**UK PROPOSAL TO AMEND  
DOCUMENT ECE/TRANS/WP.29/GRPE/2007/8**

**PROPOSAL**

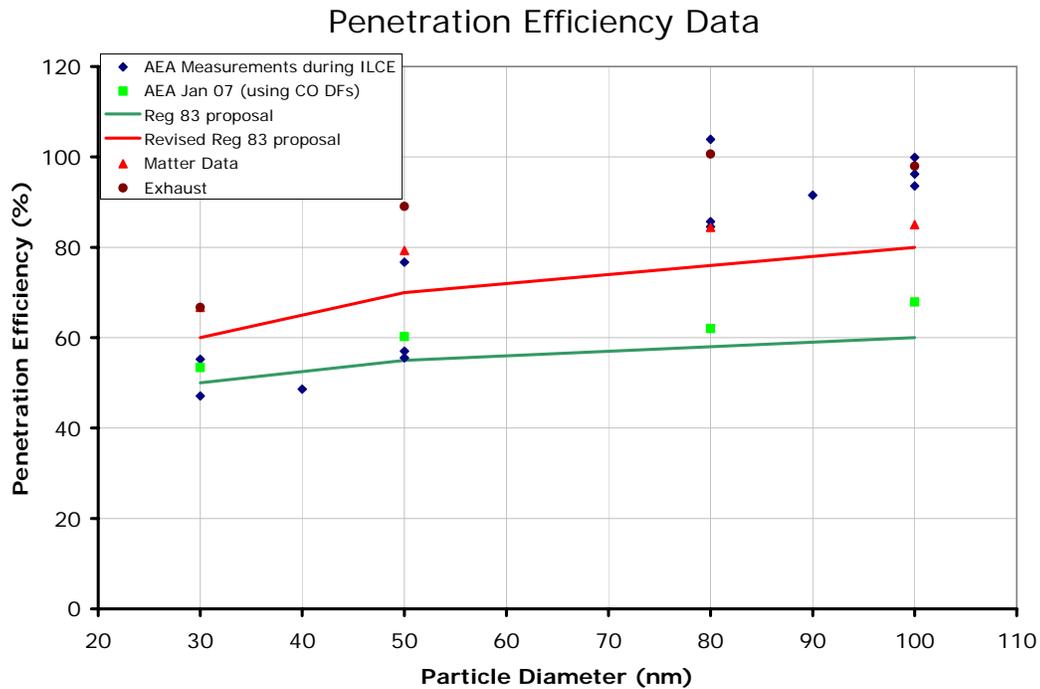
The Volatile Particle Remover (VPR) penetration efficiencies specified in ECE/TRANS/WP.29/GRPE/2007/8 were based on AEA's measurements of VPR penetration efficiency during the PMP Light Duty Inter-Laboratory Comparison Exercise. Subsequent measurements by AEA on the Golden System using exhaust particles, by Matter Engineering on clones of the Golden System and by Horiba on their Solid Particle Counting System showed much higher penetration efficiency results.

NB: Matter and Exhaust data for 30nm coincident

These measurements were made using a variety of techniques. A number of differences between the methods used to obtain the high and low efficiency datasets have been identified, including aerosol generation method and neutralisation of test aerosol. These will be investigated to determine the significant factors and calibration guidance will be amended to reflect best practice currently used by instrument manufacturers.

The above proposal therefore amends the VPR penetration efficiency requirements to reflect the performance of the systems used in the PMP Light Duty Inter Laboratory Correlation Exercise when subjected to vehicle exhaust or calibrated according to their manufacturers' procedures.
